06-002/14 - MULTI-MODEL - UNUSUAL NOISE WHEN STARTING TO MOVE VEHICLE WHILE STEERING WHEEL IS TURNED TO FULL LEFT POSITION

Subject: UNUSUAL NOISE WHEN STARTING TO MOVE VEHICLE WHILE STEERING WHEEL IS TURNED TO FULL LEFT POSITION	Bulletin No: 06-002/14
	Last Issued: 07/29/2014

- This bulletin supersedes the previous bulletin 06-002/13, issued on 10/09/13. The APPLICABLE MODEL(S)/VINS, DESCRIPTION, REPAIR PROCEDURE, PART(S) and WARRANTY INFORMATION have been revised.
- Changes are noted below in Red beside the change bar.

DESCRIPTION

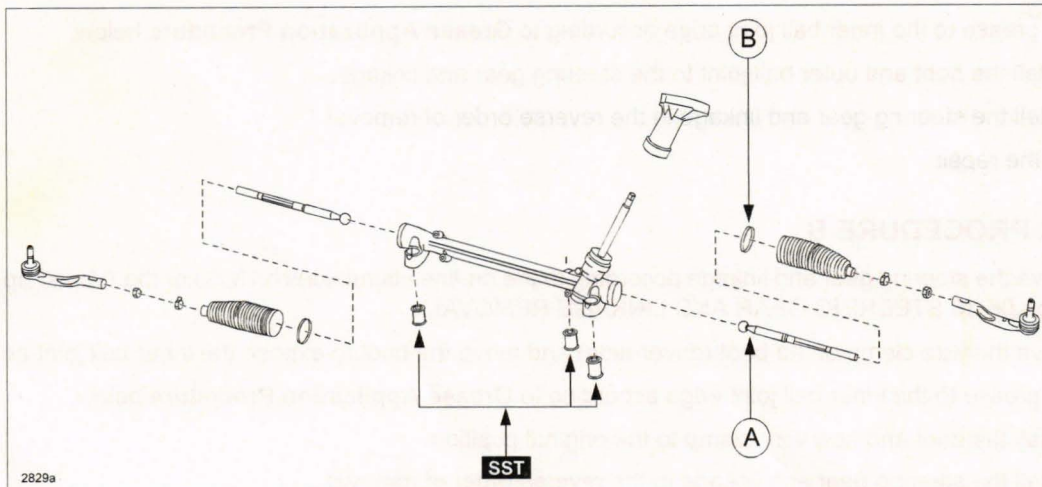
The noise is caused when the edge of the left side inner ball joint (A) gets stuck with the steering gear housing.

The following modifications have been made to eliminate the noise:

1. The shape of the inner ball joint edge has been changed.
2. Grease has been applied to the inner ball joint edge.

REPAIR PROCEDURE A

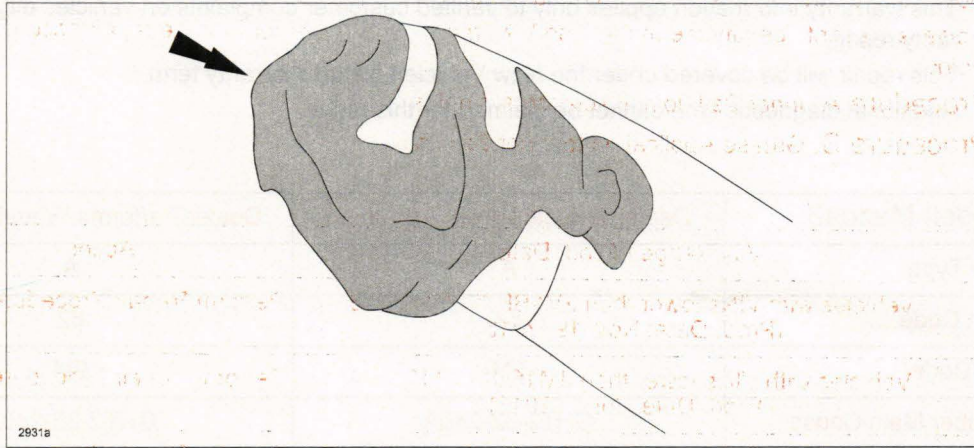
1. Remove the steering gear and linkage according to the on-line instructions on MS3 or the Workshop Manual (section 06-13 STEERING GEAR AND LINKAGE REMOVAL).
2. Replace the left inner ball joint according to the on-line instructions on MS3 or the Workshop Manual (section 06-13 STEERING GEAR AND LINKAGE DISASSEMBLY).
3. Apply grease to the inner ball joint edge according to **Grease Application Procedure** below.
4. Reinstall the boot and outer ball joint to the steering gear and linkage.
5. Reinstall the steering gear and linkage in the reverse order of removal.
6. Verify the repair.

Grease Application Procedure:

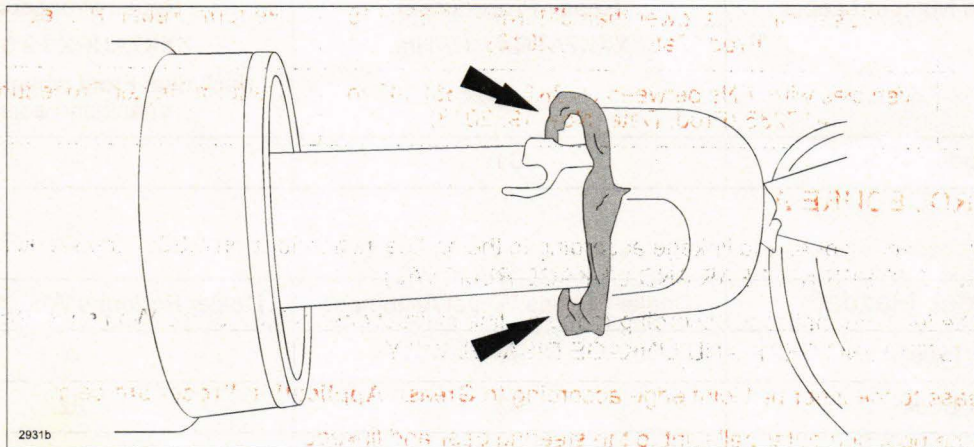
1. Squeeze approx. 1cc of grease out of the tube onto your finger.

2. Apply the grease all the way around the inner ball joint edge.
